**Request
for
Continued Examination (RCE)
Transmittal**

Application No.: : 10/798,693
Applicant : Eddie N. Stanton and Michael L. Strickland
Filed : 03/11/2004
TC/A.U. : 3673
Docket No. : CLPS-18789
Customer No. : 01224
Confirmation No. : 6180

RESPONSE TO OFFICE ACTION DATED JUNE 10, 2009

Amendments to the Drawings: Replacement Sheets for Figures 4, 6, and 12.

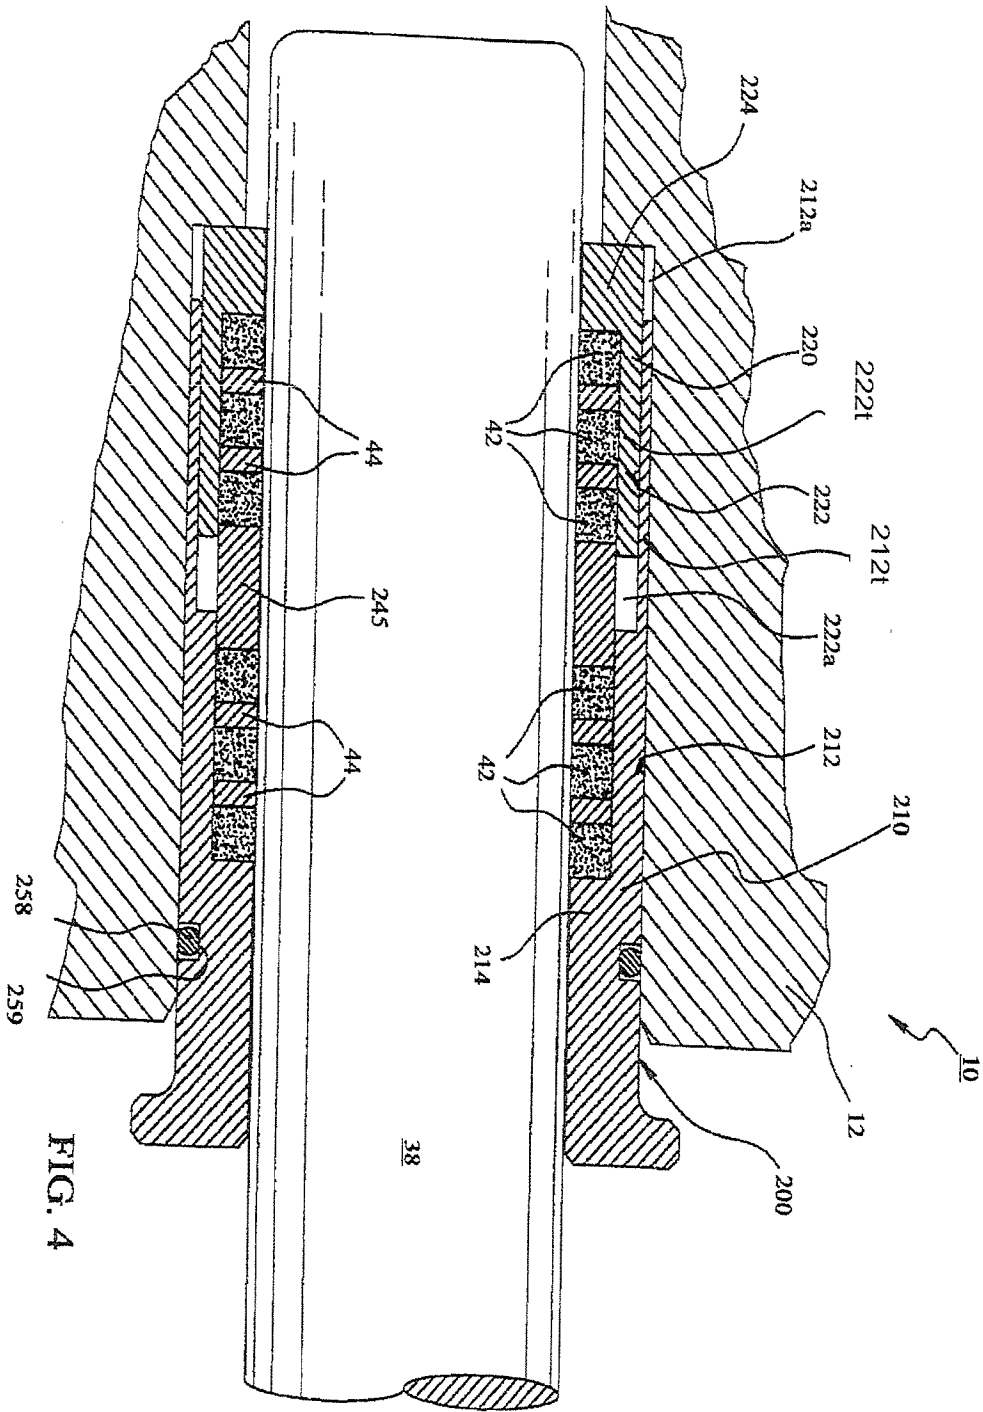
In response to objections to the drawing under 37 CFR 1.83(a), Applicants amend the specification to include references and submit Replacement Sheets for Figures 4, 6, and 12.

The drawings were objected to under 37 CFR 1.83(a) because the specific terms “telescoping structures” as used in the currently- pending claims were not identified in the drawings. Applicants amend as required by the Examiner.

Regarding Figure 4, Paragraphs 0145 and 0146 of the specification are amended to include the specific references 212t and 222t for the “telescoping structures” and Figure 4 of the drawing is amended to include these references. Further support for these amendments is found in the specification, for example, in Paragraph 0145:

[0145] As will be appreciated, the telescoping structures 212t and 222t of the first sleeve portion **212** and the second sleeve portion **222** allow for squeezing of the first abutment ring **214** and the second abutment ring **224** co-axially closer to one another after positioning the pre-assembled packing cartridge **200** on a plunger **38** in the packing bore **28**. This axial squeezing is initially provided by the gland nut **32** (not shown in **Figure 4**). The gland nut initially can be tightened to the specifications of the packing elements **42**. In addition, from time to time, the gland nut can be tightened further to further squeeze the packing elements **42** in compensation for wear during operation of the pump. Preferably, these telescoping structures 212t and 222t allow for at least sufficient overlapping travel in areas **212a** and **222a** to allow for the expected crushing of packing during the operation of a plunger **38** though the packing cartridge **200**. For example, the expected crush of the packing rings may be about 0.4 inches.

[0146] Preferably, a spacer ring **245** is positioned operatively to cover the overlapping travel of inwardly exposed area **222a** of the telescoping structures 212t and 222t between the first and second sleeve portions **210** and **220**. This spacer ring **245** helps prevent seepage of fluid into any clearances between the first sleeve portion **210** and the second sleeve portion **220**. The spacer ring **245** can also act as a back-up ring for the packing rings **42**.

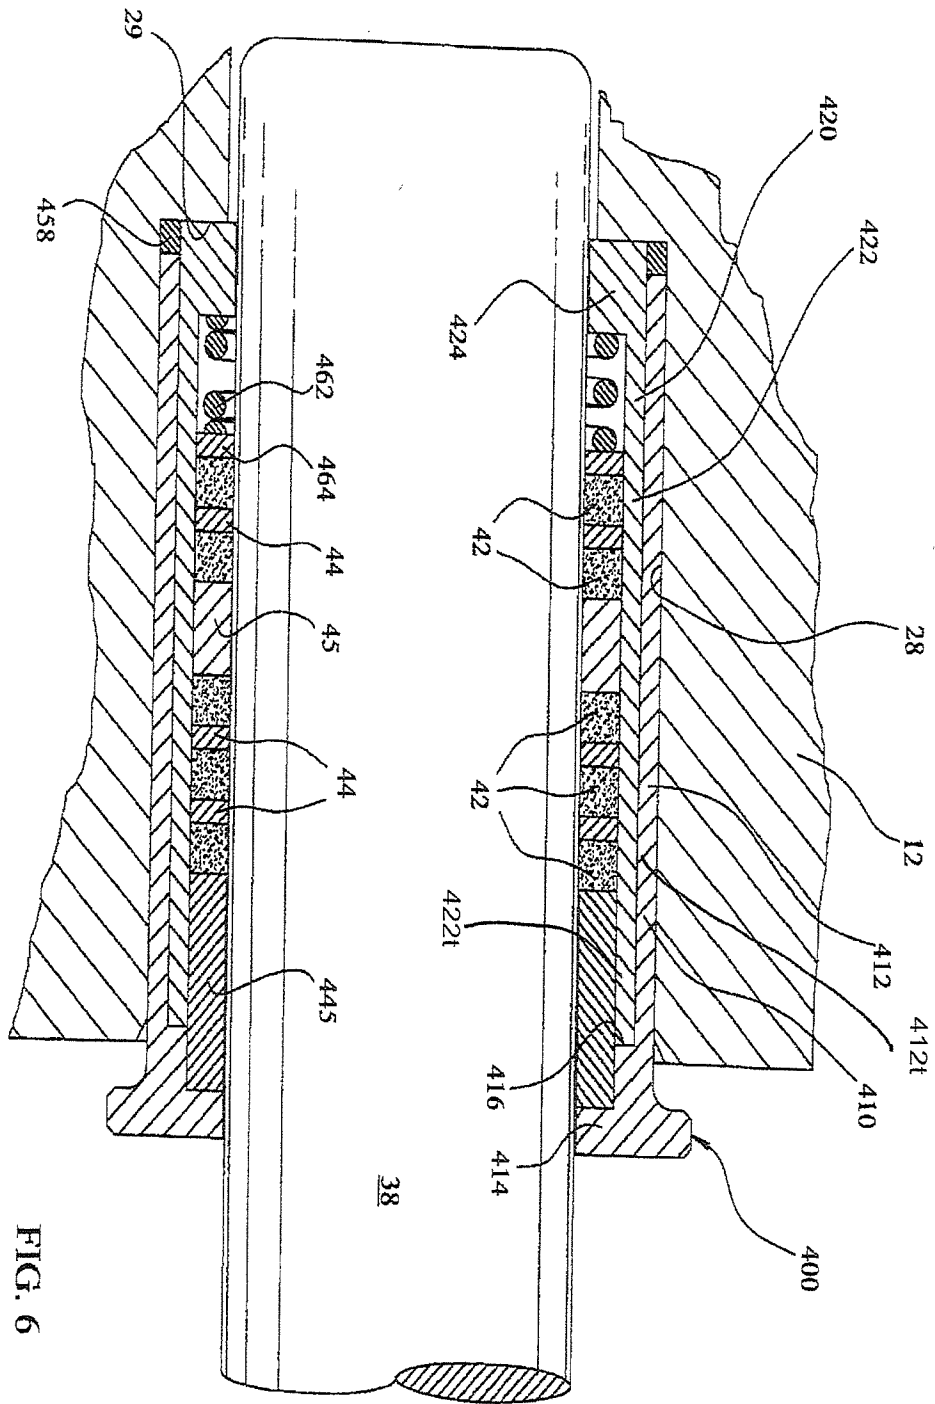
Regarding Figures 6 and 12, Paragraphs 0156 and 0158 of the specification are amended to include the specific references 412t and 422t for the “telescoping structures” and Figures 6 and 12 of the drawing is amended to include these references. Figure 12 is a cross-sectional view of another embodiment of a packing cartridge similar to the embodiment shown in Figure 7 (*See, e.g.*, Specification Paragraphs 0076 and 0193), where Figure 7 is a cross-sectional view of another embodiment of a packing cartridge similar to the embodiment shown in Figure 6 (*See, e.g.*, Specification Paragraphs 0068 and

In response to the new objection to the drawing in the Final Office Action of June 10, 2009, Applicants respectfully note that a “seat 29” is indicated in Figures 1, 3, 3a, 6, 9, 14a, 15, and 17. Figure 7 is similar to Figure 6 as described in Paragraph 0161, and Figure 12 is similar to Figure 7 as described in Paragraph 0193. In addition, the Replacement Sheet for Figure 12 submitted herewith is amended to indicate seat 29.

[0156] Preferably, a spacer ring **445** is positioned operatively to cover the overlapping travel of the telescoping structures 422t and 412t between the first and second sleeve portions **410** and **420**. This spacer ring **445** helps prevent seepage of fluid into any clearances between the first sleeve portion **410** and the second sleeve portion **420**. The spacer ring **445** can also act as a back-up ring for the packing rings **42**.

[0158] As will be appreciated, the telescoping structures 422t and 412t of the first sleeve portion **412** and the second sleeve portion **422** allow for squeezing of the first abutment ring **414** and the second abutment ring **424** co-axially closer to one another after positioning the pre-assembled packing cartridge **400** on a plunger **38** in the packing bore **28**. However, in this embodiment, the packing cartridge **400** is positioned in the packing bore **28** and tightened by a gland nut (not shown) until the second sleeve portion **422** bottoms out against a shoulder **416** of the first sleeve portion **412**. In this position, the coil spring **462** is compressed with a packing assembly positioned between the first abutment ring **414** and a second abutment ring **424**. The advantage of bottoming out the telescoping structures 422t and 412t is that it prevents over-tightening of the packing cartridge **400** in the packing bore **28**. The spring **462** maintains a pre-determined amount of axial compression on the packing rings **42** of the packing stack.
